RE: Farmers Sand/Milton Reservoir M2024057- Adequacy Review #3 - Responses and Exhibits

Attached to this email is the Division's Adequacy Review #3 letter for the Farmers Sand/Milton Reservoir permit application, project number M-2024-057.

**Re: Farmers Sand, File No. M-2024-057 Receipt
of 112c Construction Materials Responses to
Adequacy Review #3**

DRAWING
R-1

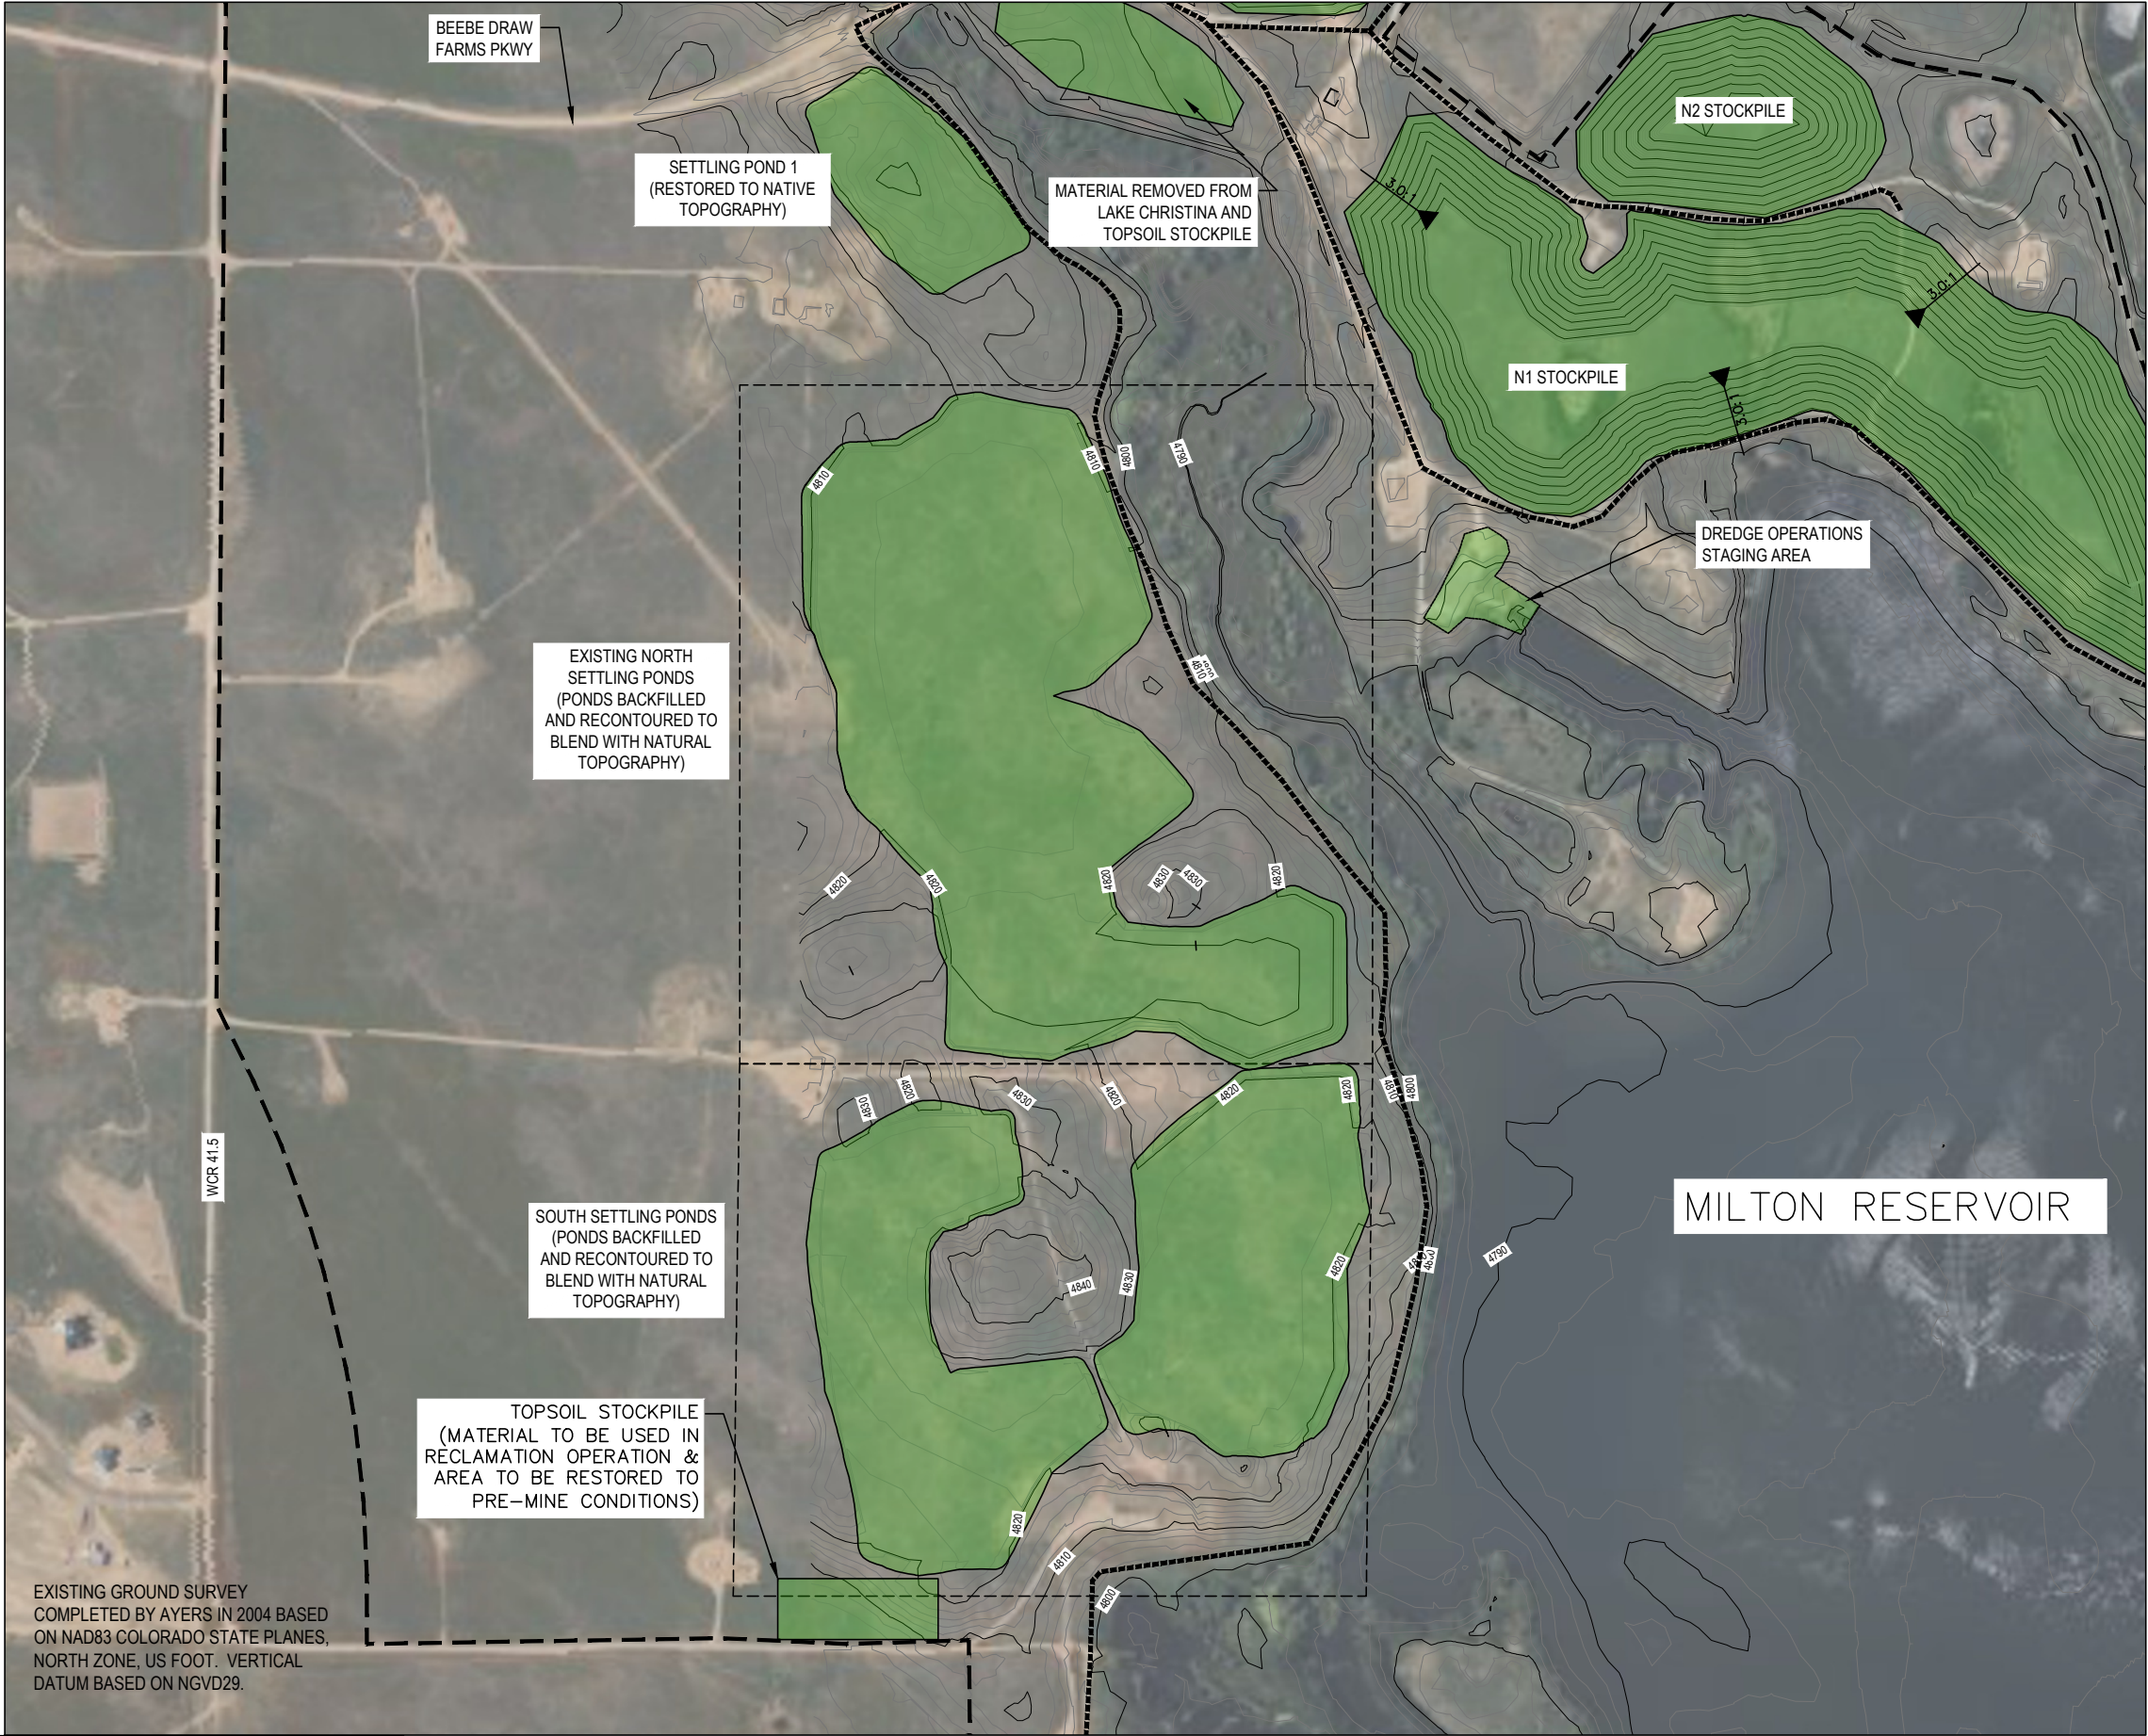
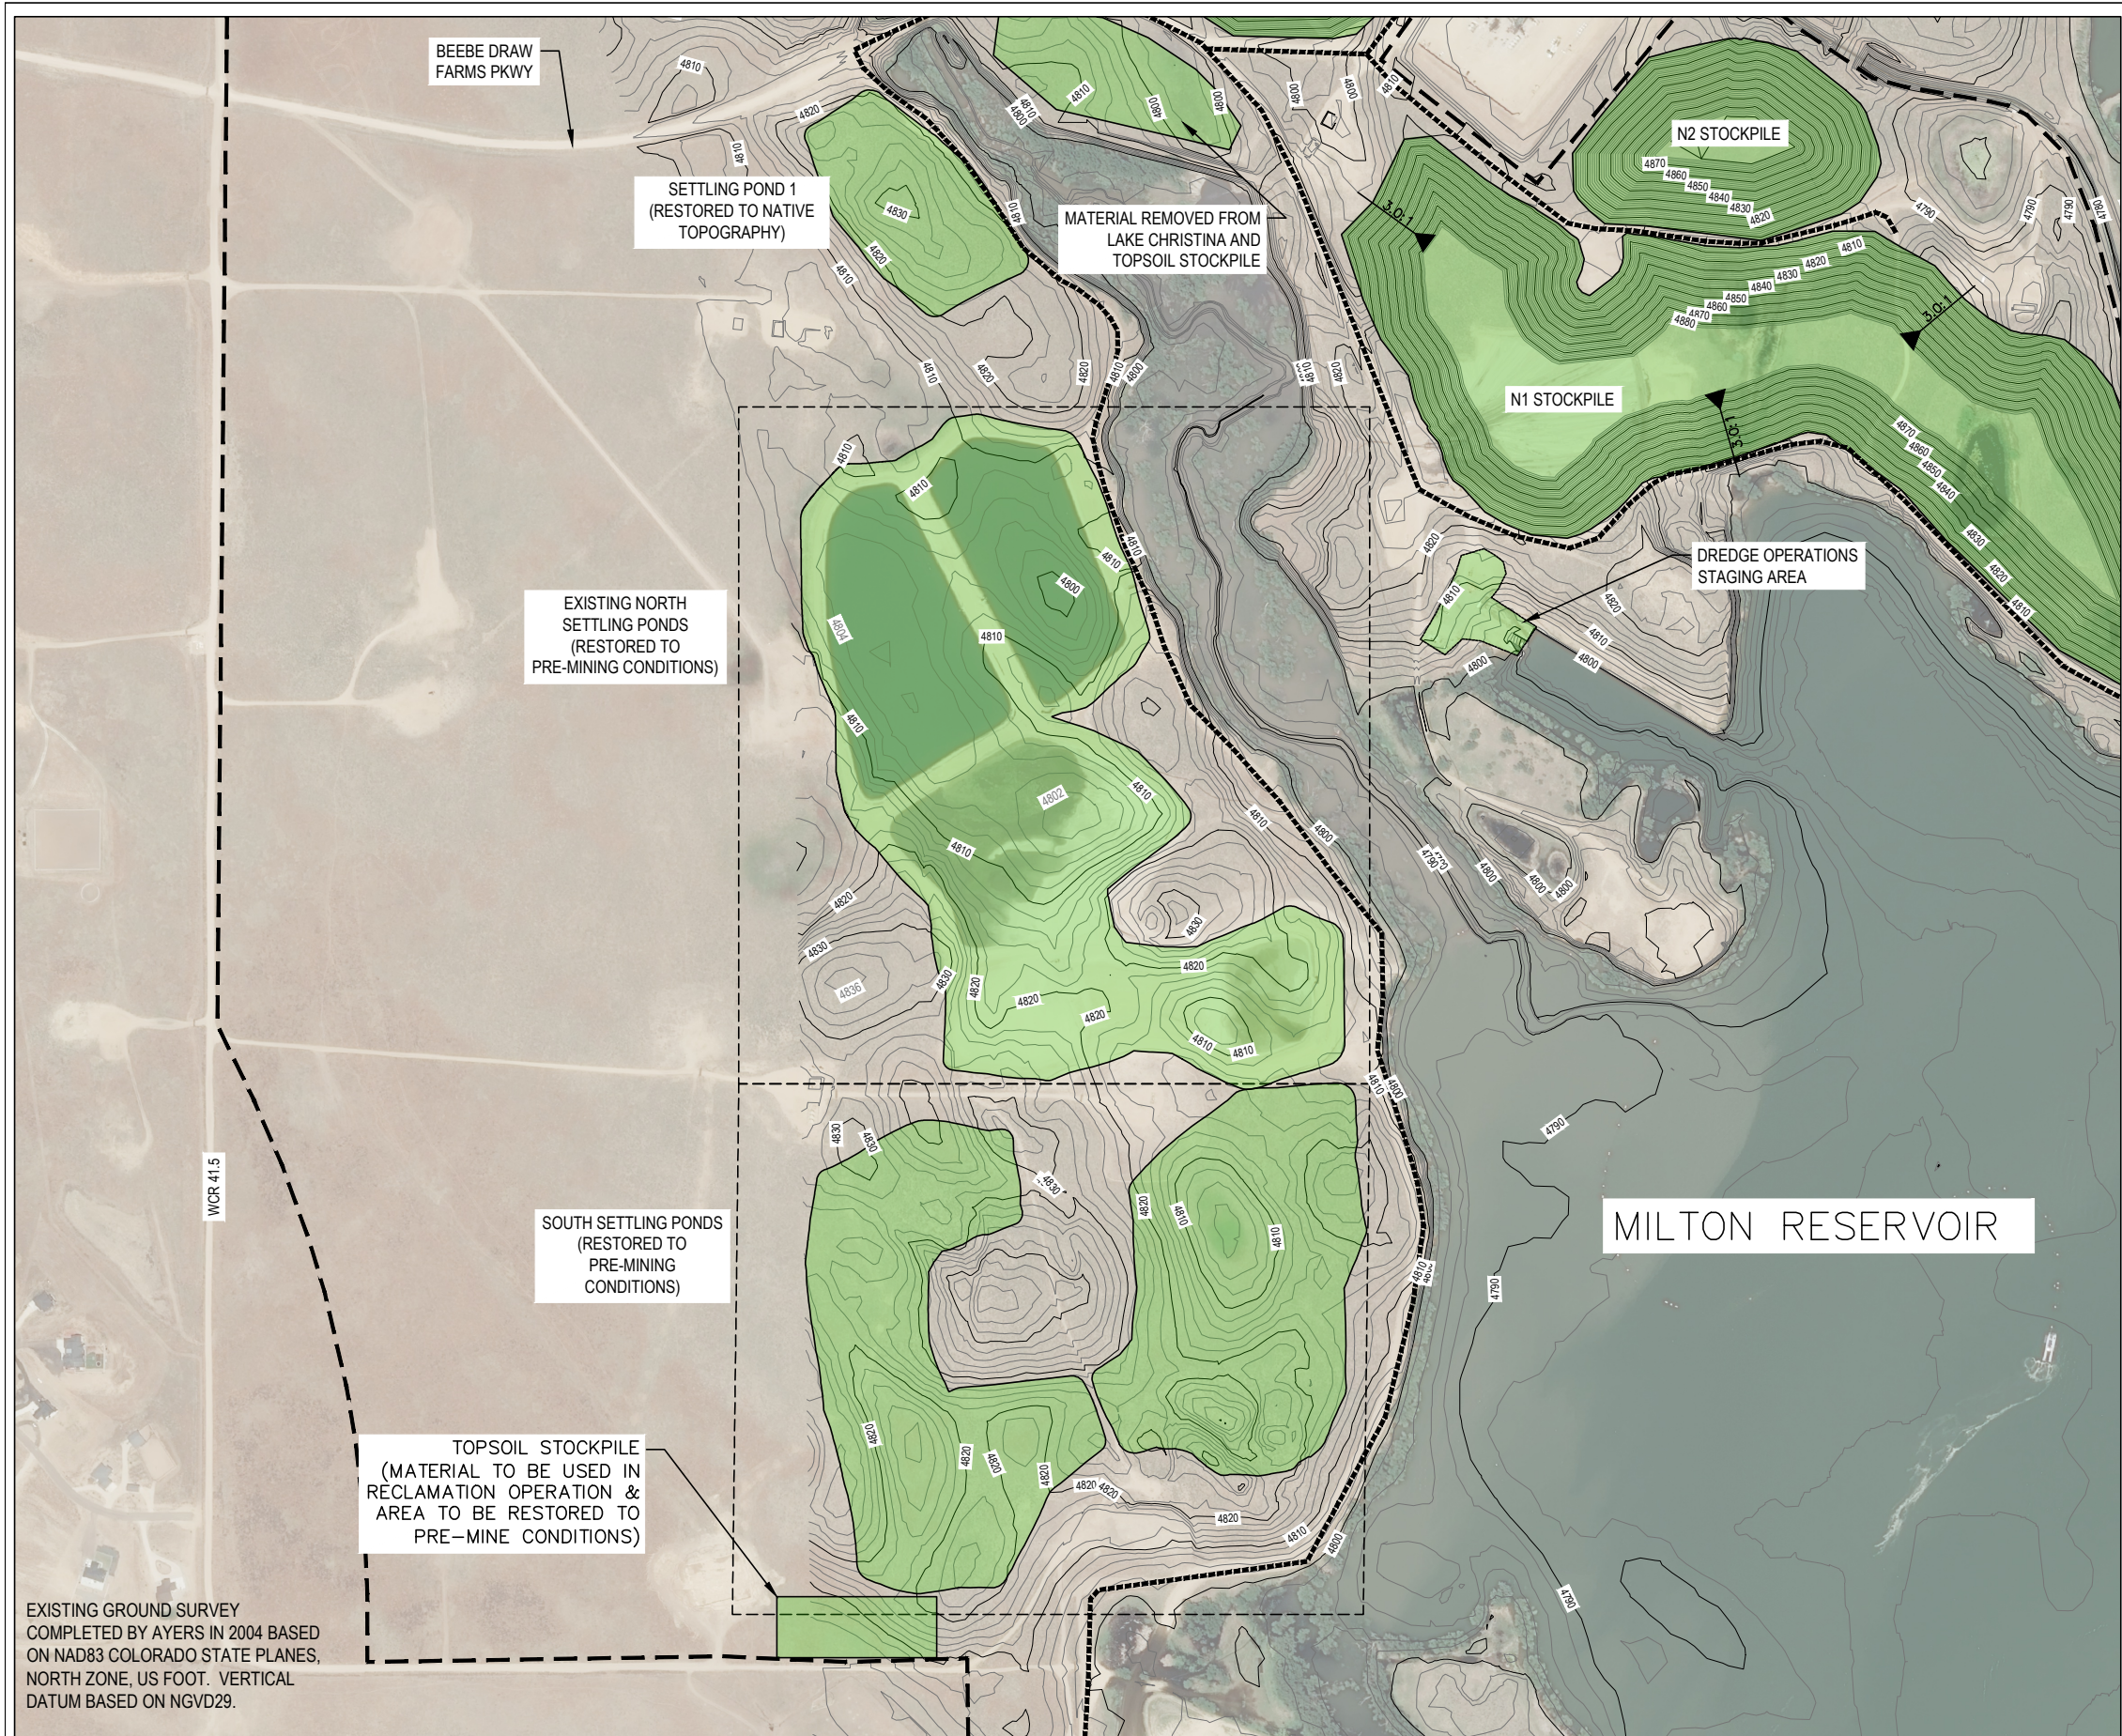
- b. **DRMS Response:** During the pre-operational inspection conducted by the Division on March 24, 2025, the Division observed stockpiles of sediment that had been excavated from Lake Christina that had been transported to an area adjacent to the east side of Platte Valley Canal within the permit area. Please update Drawing 06 in the mining plan to account for the stockpiled material. In addition, please clarify how the area will be reclaimed and update the Reclamation Plan and Maps accordingly.

- d. **DRMS Response:** The Reclamation Plan has not been revised to include discussion of this area, please revise. In addition, the Reclamation Plan states that approximately 379 acres will be revegetated. Please clarify if this number includes the Lake Christina sediment stockpile area.

- c. **FRICO Response:** This stockpile area will be reclaimed the same as the other stockpile areas where the slopes will be developed with an overall angle of 3H:1V as the final configuration, resulting in a roughly graded outer surface. Additional grading will be completed as needed to establish more uniform contours that align with the existing topography. Once the slopes have been graded, they will be scarified in preparation for seeding and mulching in accordance with the Reclamation Plan. The revised Reclamation Plan and Drawings R-1, R-2A, and R-2B are included in attached Exhibits E and F, respectively.

FRICO Response: The project area has been updated from 379 acres to 399 acres to include the topsoil and Lake Christina sediment stockpiles. The Reclamation Plan and Mining Plan have been revised to include a discussion of the material removed from Lake Christina and the receiving stockpiles. See attached revised Exhibit E – Reclamation Plan, Section 2.0 – Reclamation Plan and Section 2.2.7 Lake Christina Removed Material and revised Exhibit D – Mining Plan, Section 4.5 Lake Christina Removed Material.
